Proposal for 02 series of amendments to UN Regulation No. 134 (Hydrogen and Fuel Cells Vehicles)

Submitted by the Working Party on Passive Safety *

The text reproduced below was adopted by the Working Party on Passive Safety (GRSP) at its seventy-third session (ECE/TRANS/WP.29/GRSP/73 para. 37). It is based on ECE/TRANS/WP.29/GRSP/2023/8 as amended by GRSP-73-54. It is submitted to the World Forum for Harmonization of Vehicle Regulations (WP.29) and to the Administrative Committee (AC.1) for consideration at their November 2023 sessions

Figure 1
Verification test for performance durability (hydraulic)

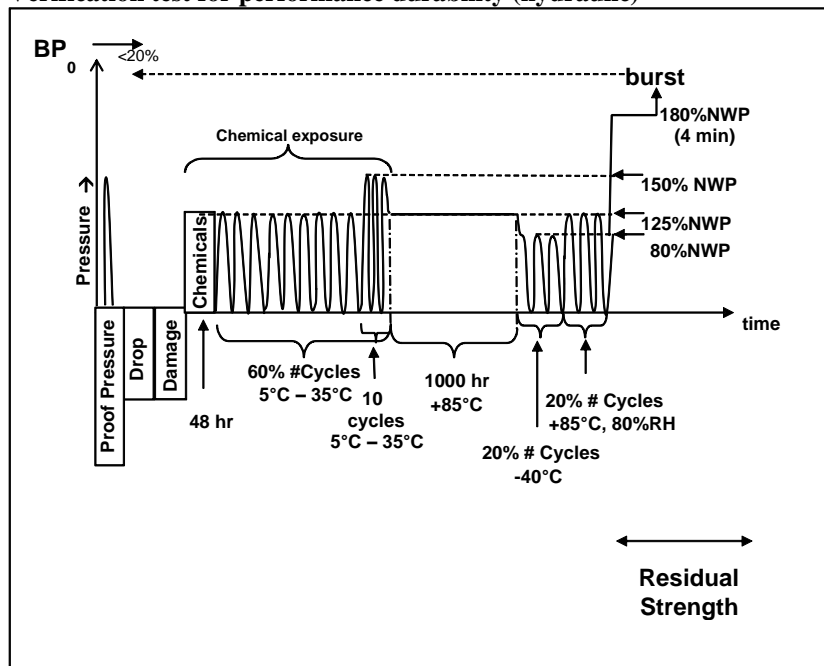
If all three pressure cycle life measurements made in paragraph 5.1.2. are greater than 11,000 cycles, or if they are all within ± 25 per cent of each other, then only one (1) container is tested in paragraph 5.2. Otherwise, three (3) containers are tested in paragraph 5.2.

Unless otherwise specified, the tests in paragraph 5.2 shall be conducted on the container equipped with its container attachments (if any) that represents the CHSS without the primary closures.

The container shall not leak during the following sequence of tests, which are applied in series to a single system and which are illustrated in Figure 1. Specifics of applicable test procedures are provided in Annex 3, paragraph 3.

Figure 2
Verification test for expected on-road performance (pneumatic)

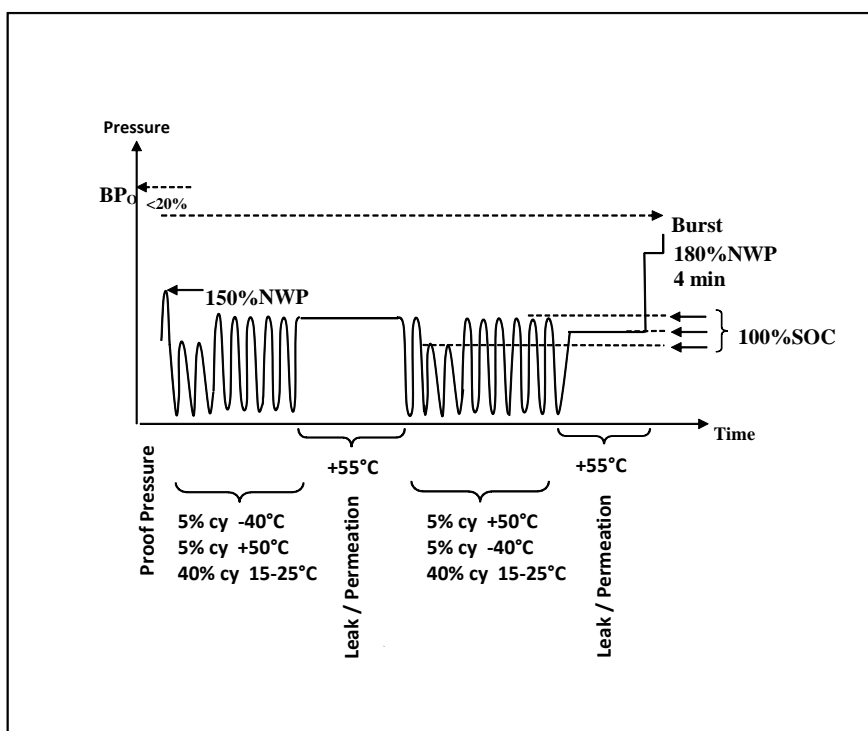
CHSS shall undergo the following sequence of tests, which are illustrated in Figure 2. Specifics of applicable test procedures for the CHSS are provided in Annex 3.

The CHSS shall not leak and the primary closure devices shall maintain functionality during the test.

Figure 3
Generic description of test pulses

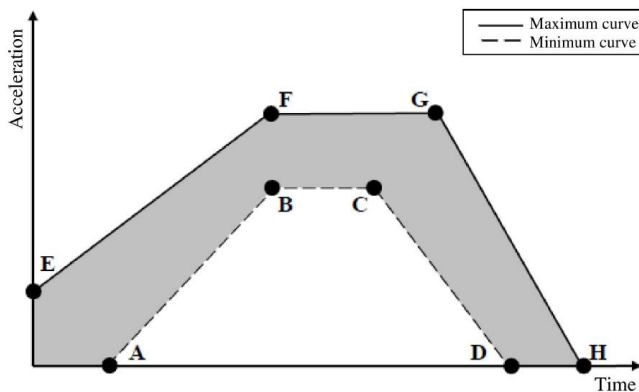
The test pulse shall be within the minimum and maximum value as specified in Tables 3 to 5. A higher shock level and /or longer duration as described in the maximum value in Tables 3 to 5 can be applied to the CHSS if recommended by the manufacturer.

Figure 1
Drop orientations

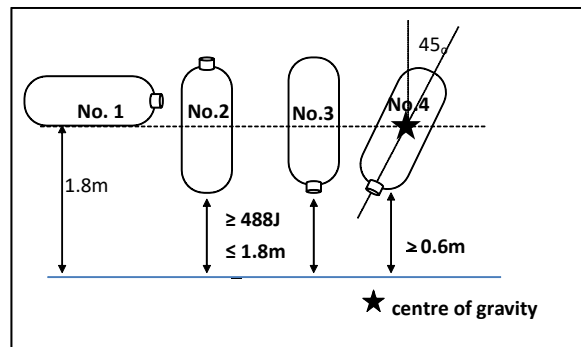
- (iv) From a 45° angle from the vertical orientation with the shut-off valve interface location downward with its centre of gravity at 1.8 m above the ground. However, if the bottom is closer to the ground than 0.6 m, the drop angle shall be changed to maintain a minimum height of 0.6 m and a centre of gravity at 1.8 m above the ground. In case of non-axisymmetric container, the line passing the shut-off valve interface location end and its centre of gravity shall be 45° angled from vertical orientation and the shut-off valve interface location shall become the lowest.

The four drop orientations are illustrated in Figure 1.

Figure 2
Surface damage flow chart

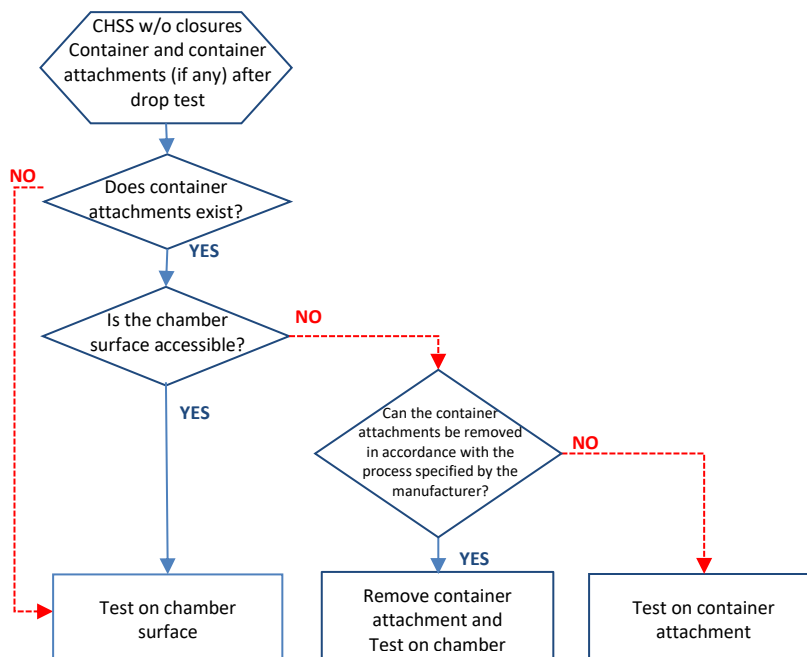
If the container attachments can be removed in accordance with the process specified by the manufacturer, then the container attachments shall be removed, and the tests shall be conducted on the surface of the pressure bearing chamber of the container.

Otherwise, the tests shall be conducted on the surface of the container attachments as indicated in Figure 2.

Figure 4
Temperature profile of fire test

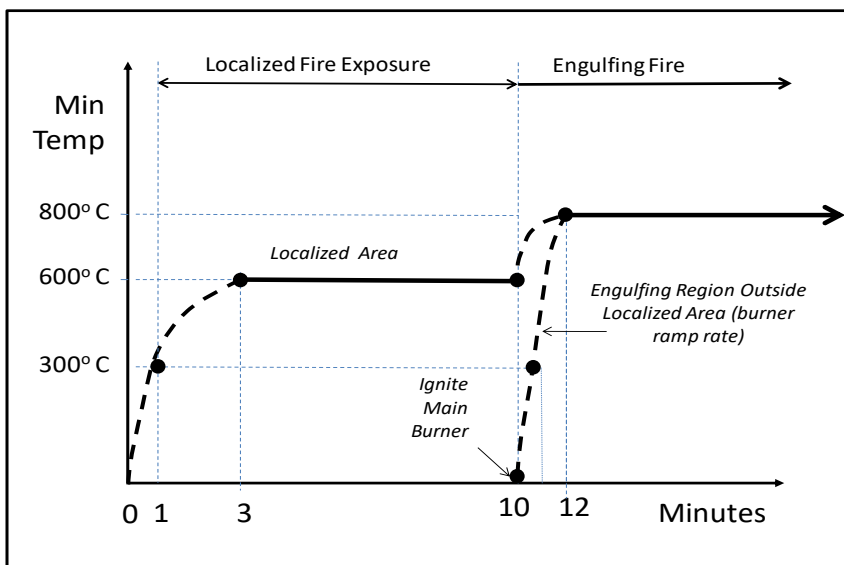
5. Test procedures for two-stage localized/engulfing fire test (paragraph 5.4. of this UN Regulation)

The test consists of two stages: a localized fire stage followed by an engulfing stage as described in Figure 4.

Figure 5
Example of placement of instrumentation on the pre-test cylinder

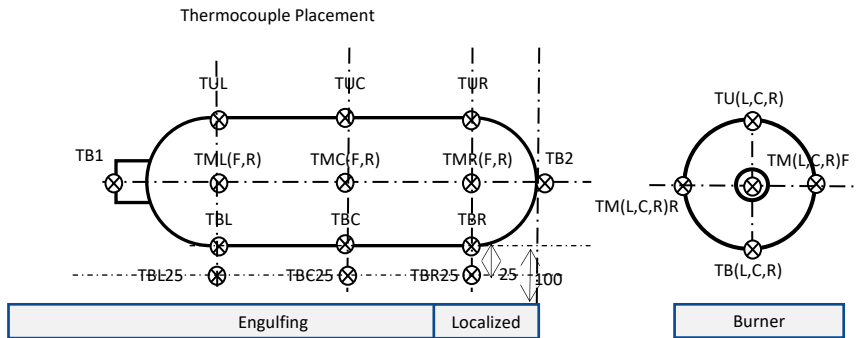
As an example of the process, Figure 5 illustrates a common situation where a container is protected by a TPRD on one end (i.e., the left end) so the localized fire zone is located on the right-end end. The surface temperatures are

measured on the top, middle, and bottom of the pre-test cylinder in three locations along the length of the cylinder. The location on the right end of the cylindrical section is centrally-located in the targeted localized zone, and the other two locations are in the centre and left ends of the targeted engulfing fire zones along the cylindrical section.

Figure 8
Position the bottom of the cylindrical container relative to the burner

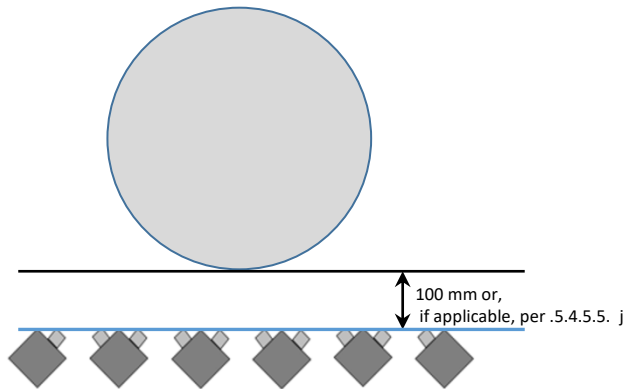
The CHSS test article shall be mounted at the same height above the burner as for the pre-test checkout in Annex 3, paragraph 5.4. and located over the burner such that nozzles on the two centrally-located manifolds (or "rails") are pointing toward the targeted region on the bottom (i.e., the lowest elevation) of the CHSS test article. See Figures 8 and 9 for examples of the mounting of cylindrical and conformable containers, respectively.
